# ULTIMATE FASHIONS LIMITED (EXTENSION)

20 February 2025

RSC RMG SUSTAINABILITY COUNCIL

**Observation 3**: Missing bolt in steel connections (RACK Shed).

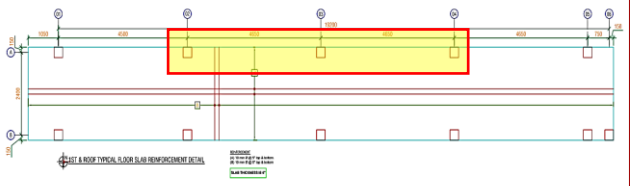
**Description:** Missing bolt in steel connections was observed at a few locations. The building engineer is required to Install the missing bolt.

| Item No. | Observation | Action Plan | Timeline |
|---|---|---|---|
| 4. | Missing bolt in steel connections (RACK Shed). | The building engineer is required to install the missing bolt. | within 6 weeks |

**Observation 5**: Dampness on a brick wall (Female Toilet Building).

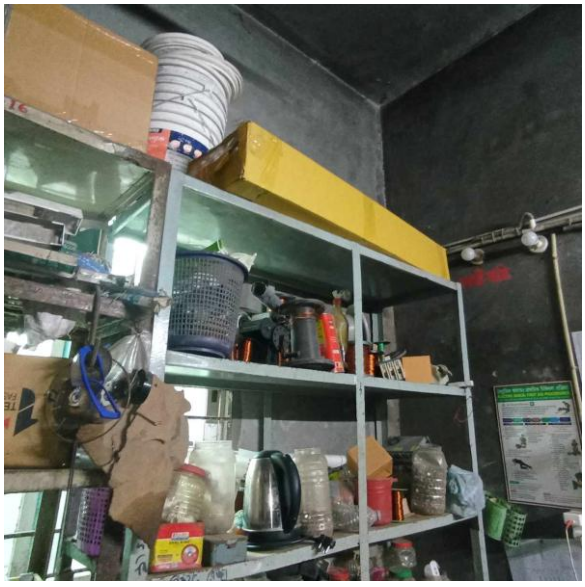
**Description:** Dampness was observed on the brick wall at several locations. The building engineer is required to repair the dampness with a suitable method.

| Item No. | Observation | Action Plan | Timeline |
|---|---|---|---|
| 10. | Dampness on a brick wall (Female Toilet Building). | The building engineer is required to repair the dampness with a suitable method. | within 6 weeks |

**Observation-6:** Nonstructural elements found not anchored/braced (Electrical Maintenance Room).

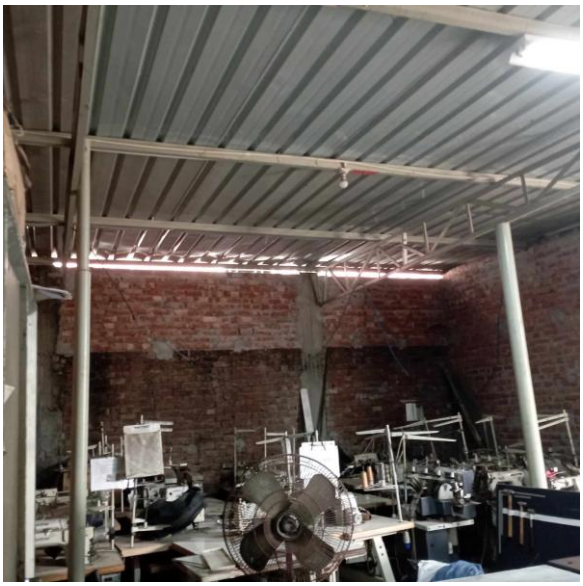
**Description:** Nonstructural elements (storage racks) were found not anchored/braced. The building engineer is required to anchor/brace all nonstructural elements within the factory.

| Item No. | Observation | Action Plan | Timeline |
|---|---|---|---|
| 11. | Nonstructural elements found not anchored/ braced (Electrical Maintenance Room). | The building engineer is required to anchor/brace all nonstructural elements within the factory. | within 6 months |

**Observation 8**: Lack of lateral stability (Workers Dining Hall).

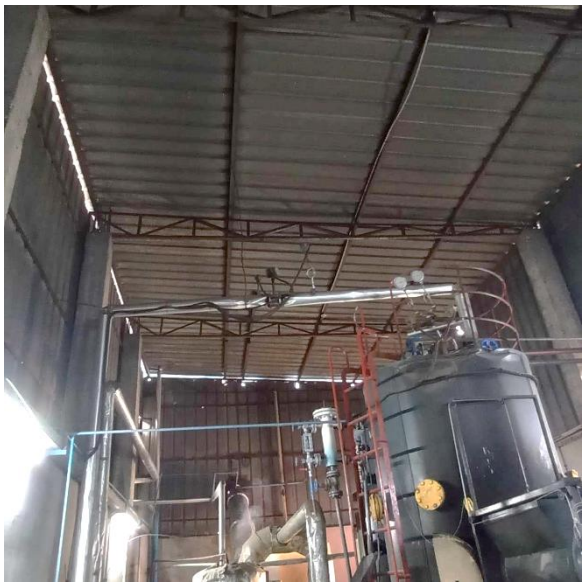
**Description:** No load transfer media, horizontal bracing and vertical bracing are provided to transfer and resist the lateral load. The building engineer is required to check the lateral stability of the shed and prepare an Engineering Assessment (EA) report as per 1.9.1 BNBC.

| 14. | Lack of lateral stability (Workers Dining Hall). | The building engineer is required to check the lateral stability of the shed and prepare an Engineering Assessment (EA) report as per 1.9.1 BNBC. | within 6 weeks |
| 15. | | Implement remediation work if required. | within 6 months |
